| PRODUCT / PROCESS CHANGE NOTIFICATION |

| 1.2 PCN No. | | ADG/21/12862 |
| 1.3 Title of PCN | | Implementation of ProBand & HIC for Acepack SMIT packaging |

3M™ Humidity Indicator Card 51060HIC125

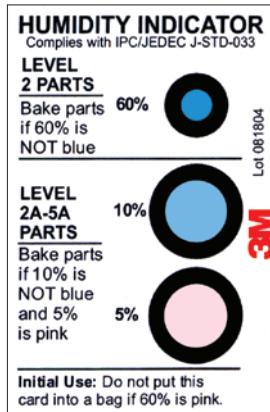
| 4.1 Description | Old | New |
|---|-------------------------------------|---|
| 4.2 Anticipated Impact on form,fit, function, quality, reliability or processability? | Standard ACEPACK SMIT T&R Packaging | Standard ACEPACK SMIT T&R Packaging, with Protective Band (Model PB10956UC) and Humidity Indicator Card (Model 51060HIC125) |

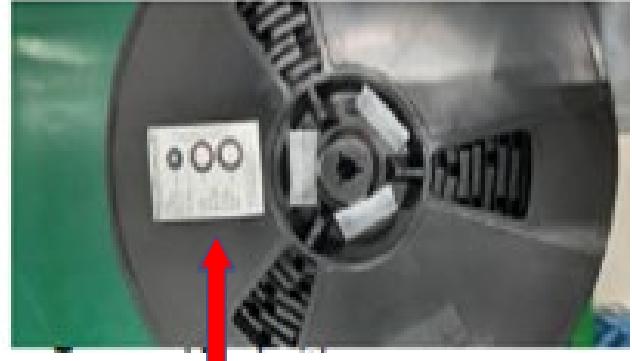
In order to improve the packaging method for our ACEPAK SMIT products delivered in T&R, we're going to introduce an additional Protective Band for the reel and a Humidity Indicator Card (HIC) to provide a more secure packaging to the units (protective band) and tighter controls on the MSL requirements of the devices through a moisture/humidity level monitoring.

| Before: | After: |
|-------------------------------------|---|
| Standard ACEPACK SMIT T&R Packaging | Standard ACEPACK SMIT T&R Packaging, with Protective Band and Humidity Indicator Card Protective Band (Model PB10956UC) Humidity Indicator Card (Model 51060HIC125) |
